JRPP No:	2011SYED26
DA No:	DA67/ 11
PROPOSED DEVELOPMENT	Demolition of existing structures, tree removal, installation of drainage infrastructure and Stage 1 concept approval for an aged care housing development and associated non residential uses at 50-52 McLaren Street, North Sydney
APPLICANT:	Uniting Care Ageing – Northern Sydney Region
REPORT BY:	Geoff Mossenear, Executive Planner, North Sydney Council

Assessment Report and Recommendation

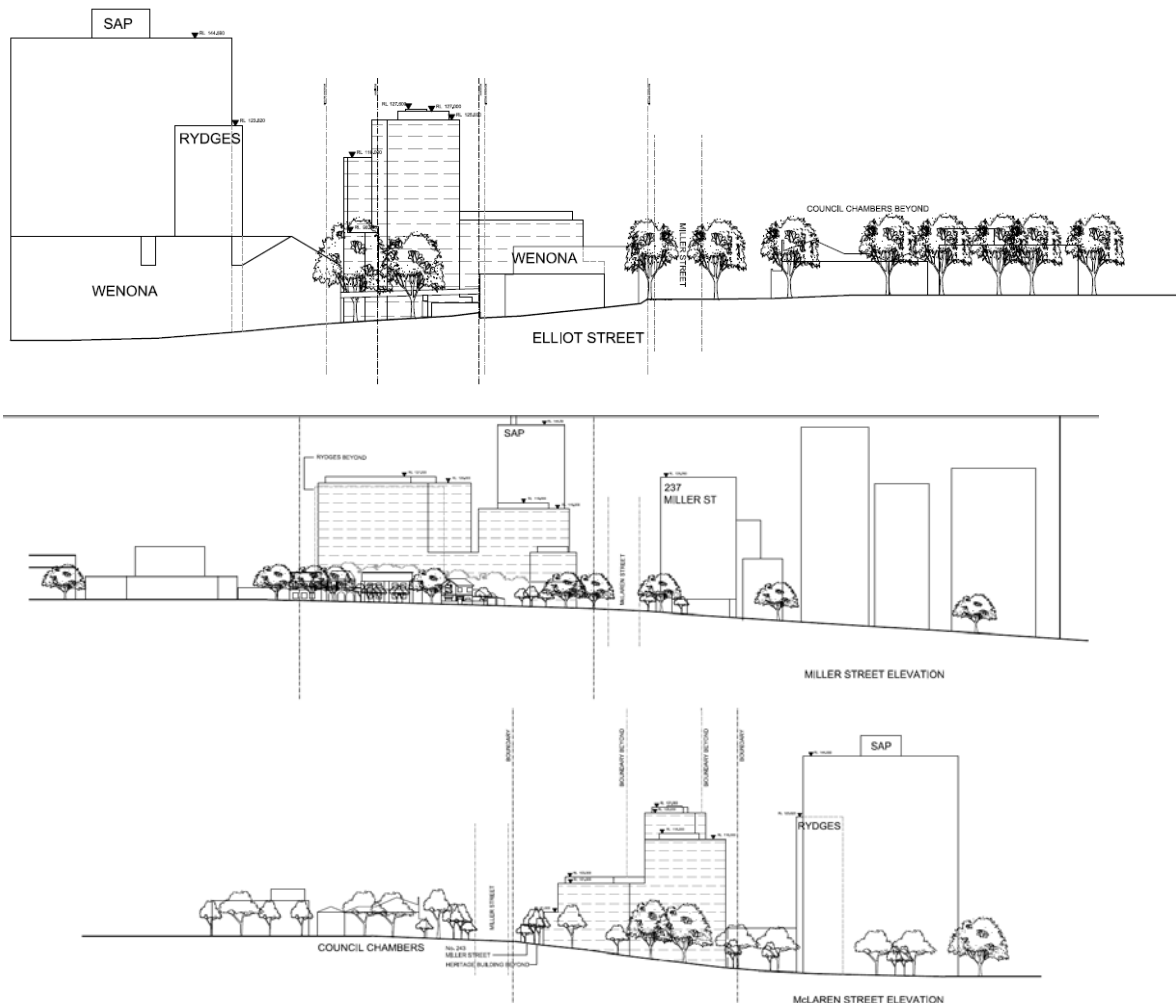
The issue is whether the transition is appropriate. It was accepted in the Castle Constructions case that the transition can be an abrupt drop. It is noted that other commercial buildings on the edge of the centre and the freeway are of similar height. However they are not adjacent to heritage buildings and low scale school buildings. On other sites on the northern edge of the CBD where they adjoin residential zones, the appropriate height is around 25m. Having regard to the notional arc in the character statement, the proposal does not fit. The sites to the northwest fronting Miller Street have a height control of 10m. It is not simply a matter of being a height similar to the Rydges building because the Rydges building has greater setbacks from the boundaries. The proposal is 3.4m higher than Rydges.

Having regard to the above elevations, it would appear that the tower A should be below the Rydges building and 237 Miller Street. When considering the height of the building, setbacks and separation must also be considered. The use is important to determine appropriate setbacks. The information accompanying the application indicates the tower to be used as an apartment building therefore SEPP65 must be taken into account. For a building over 25m in height the separation distances vary between 18m and 24m. Half the distance must be provided as adequate setback as it is not good practice to borrow from adjoining sites. The proposal has side setbacks of 6m. The minimum setbacks should be 9m. The site appears to be too narrow to accommodate a residential building of the height proposed.

- Reduce height of tower A to no more than RL 118 (to top of plant)
- Provide minimum of 6m setback from side boundaries for building up to RL 101
- Provide minimum of 9m setback from side boundaries for building over RL 101

Figure 1.1 Stepping down of building heights along Miller Street. Potential increase in height shown in light grey.

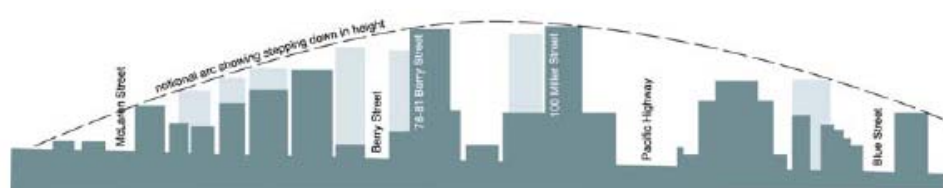
The proposed buildings are clearly well outside the notional arc.
